STERLING RANCH EAST PRELIMINARY PLAN ~~PHASE 1~~

PRELIMINARY PLAN

As discussed, project name is to remain: Sterling Ranch East Phase 1 Preliminary Plan

V2_Preliminary Plan Drawings.pdf Markup Summary 1-9-2023

TYPICAL RESIDENTIAL STREET

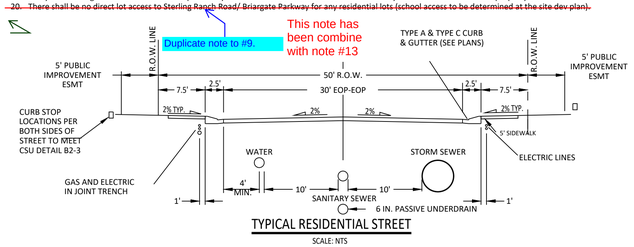
provide details

Note#13 regarding noise wall has been added. Details of noise wall shown on sheet 32

A 11 VIEWPORT 11-A

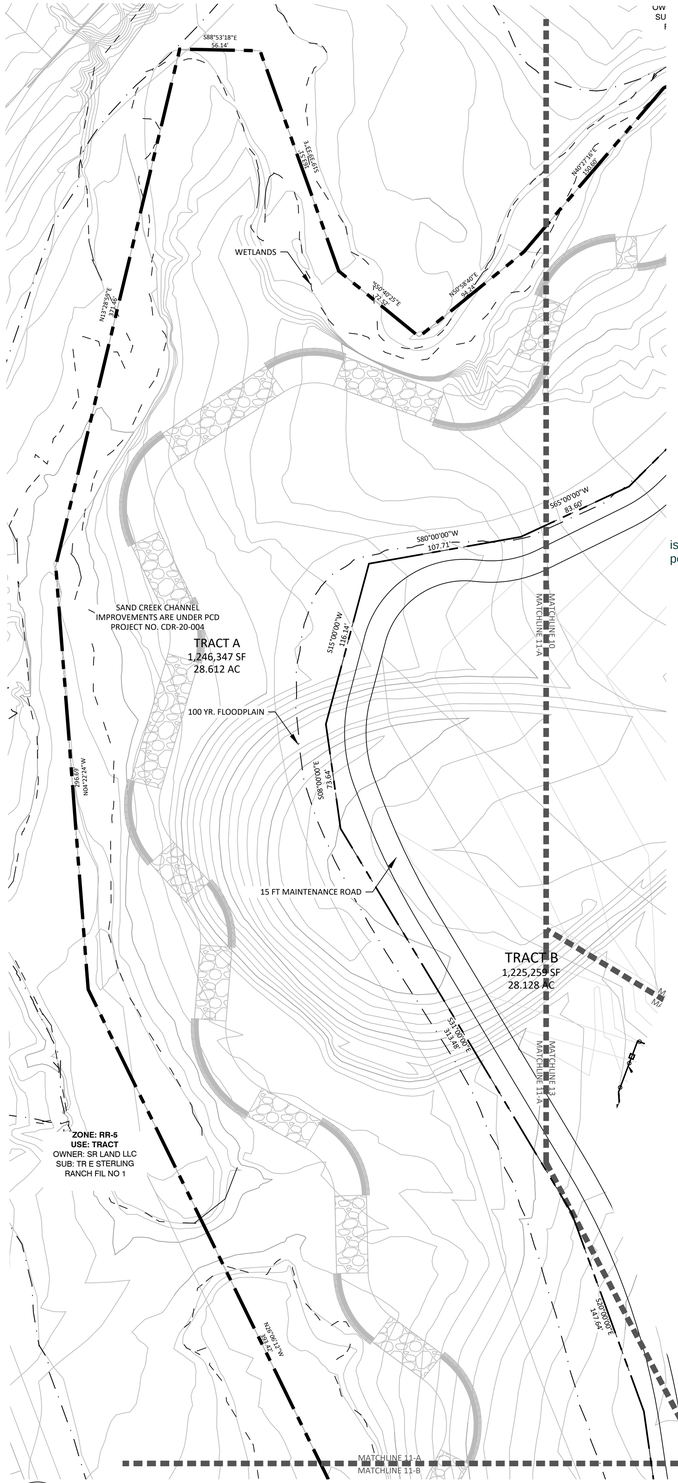
is this also a pedestrian amenity?

Yes. 15' maintenance trail 8' wide H20 loaded concrete and 7' of gravel for pedestrians. This will be owned and maintained by El Paso County.

A 20 VIEWPORT 20-A

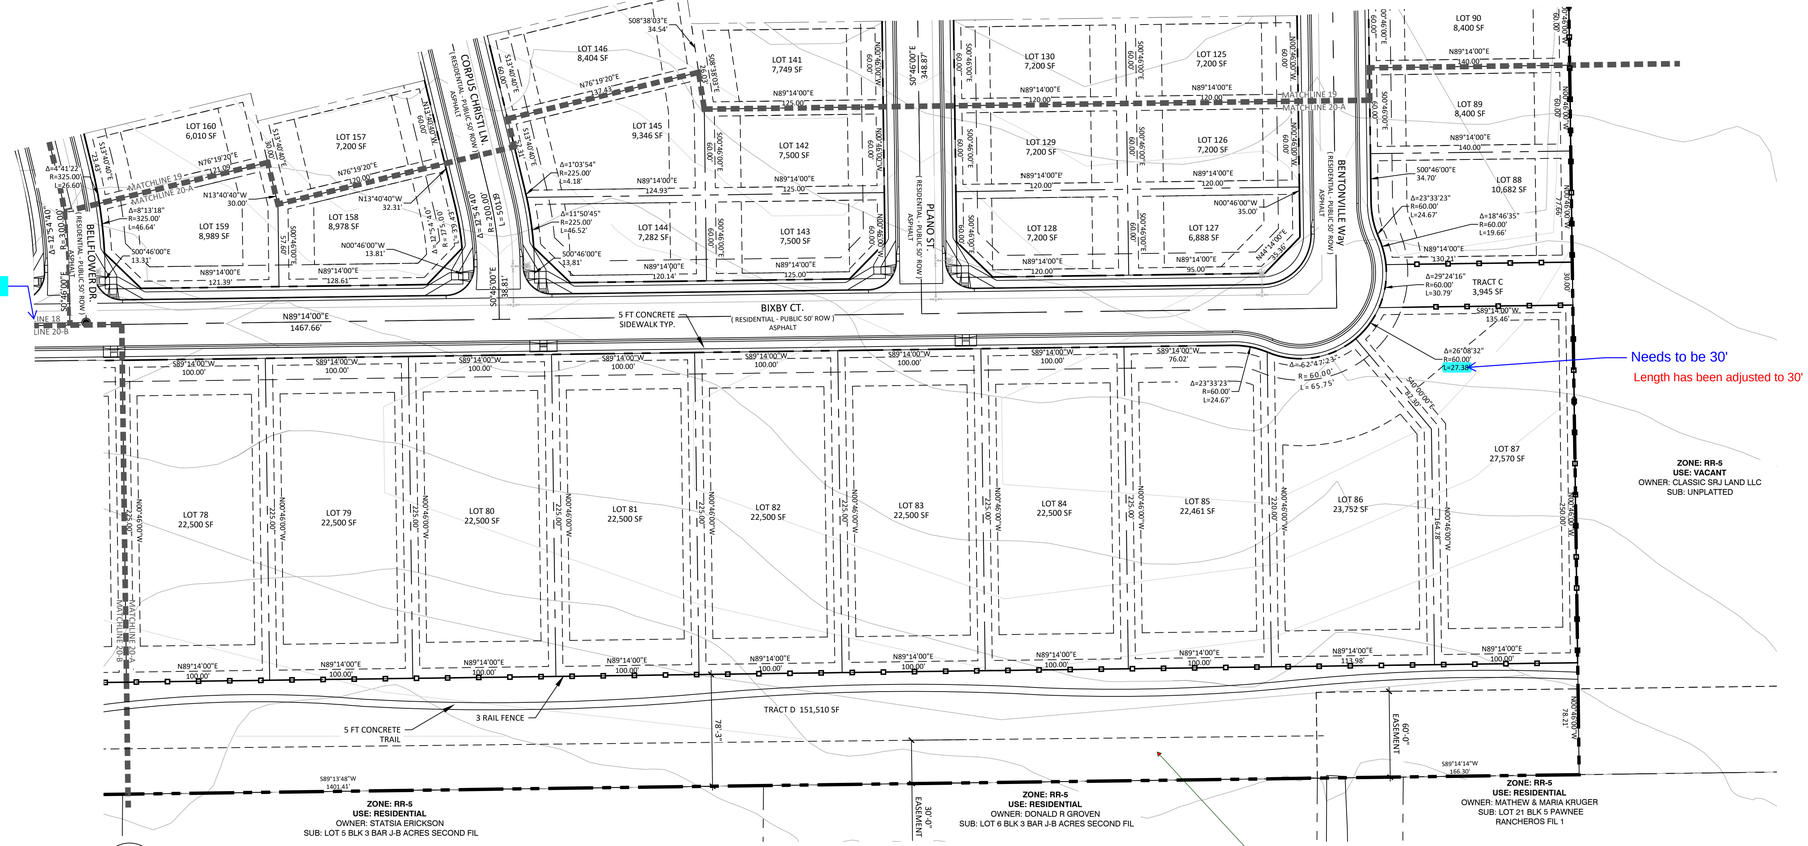
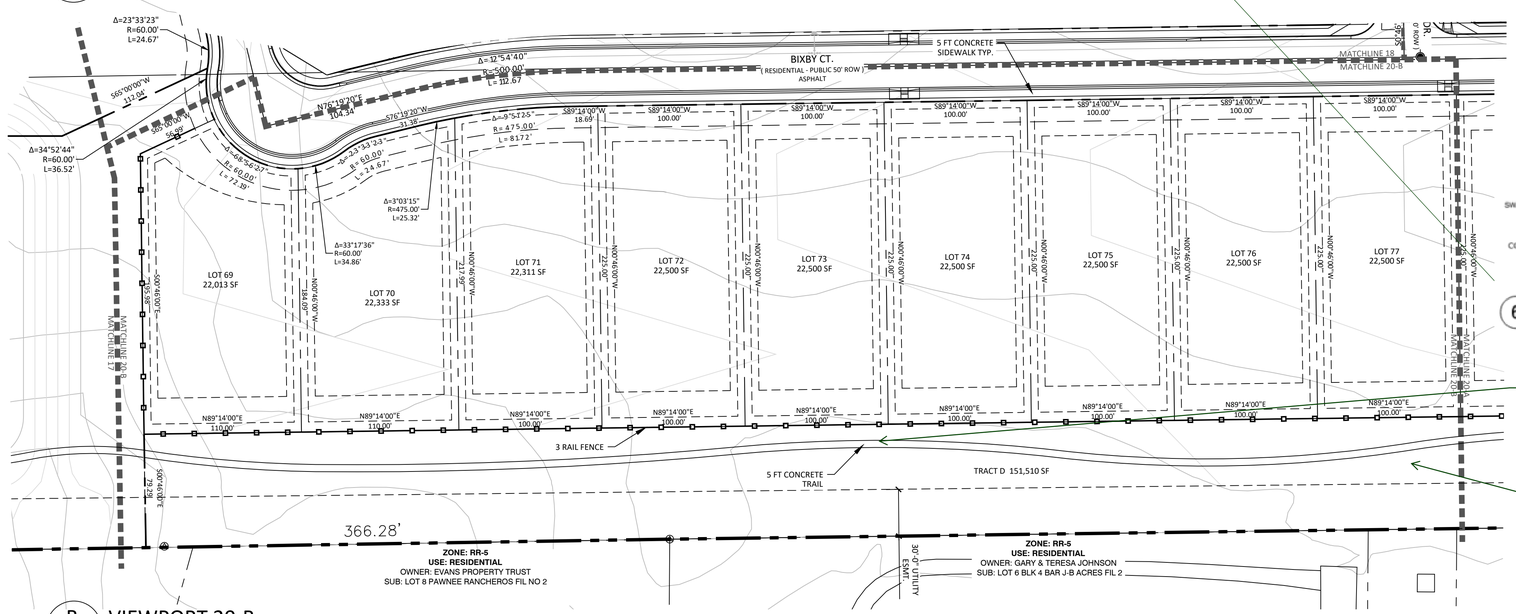
Needs to be 30'

Length has been adjusted to 30'

6 CONCRETE TRAIL

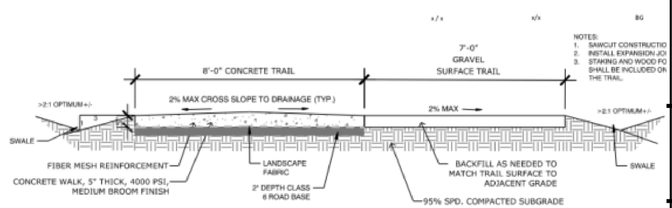
I though this was equine connection trail but its concrete> ? please match detail

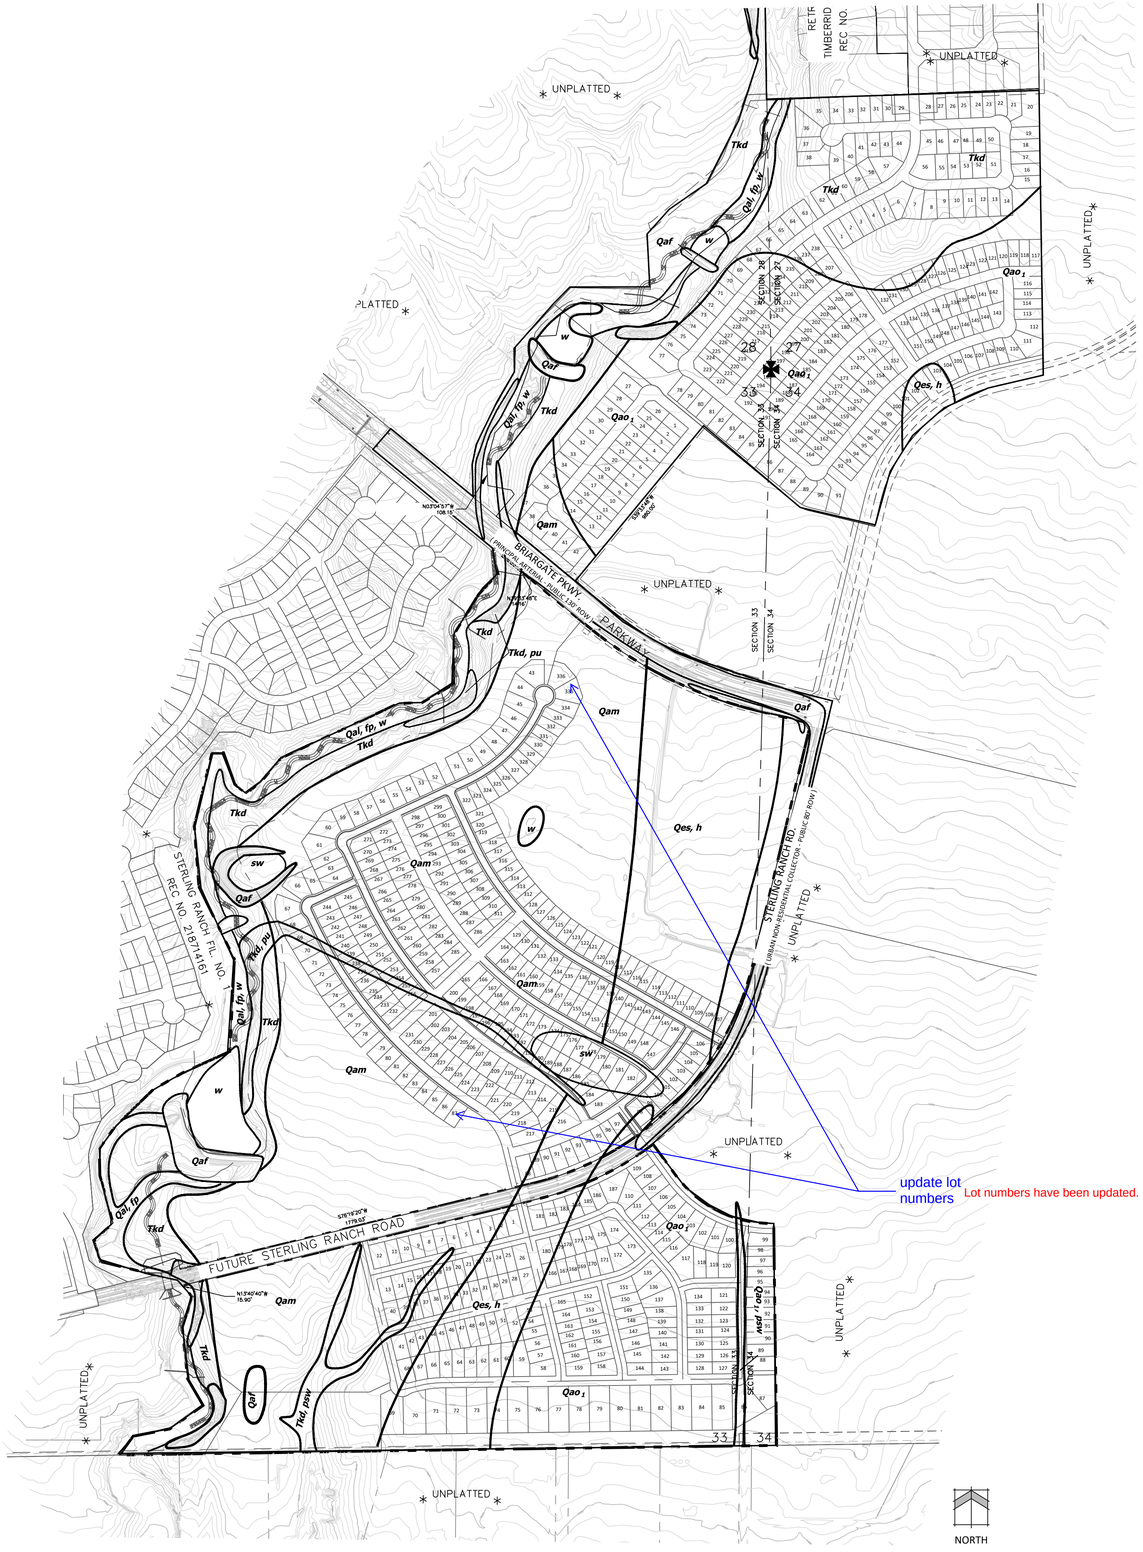
update lot numbers

Lot numbers have been updated.
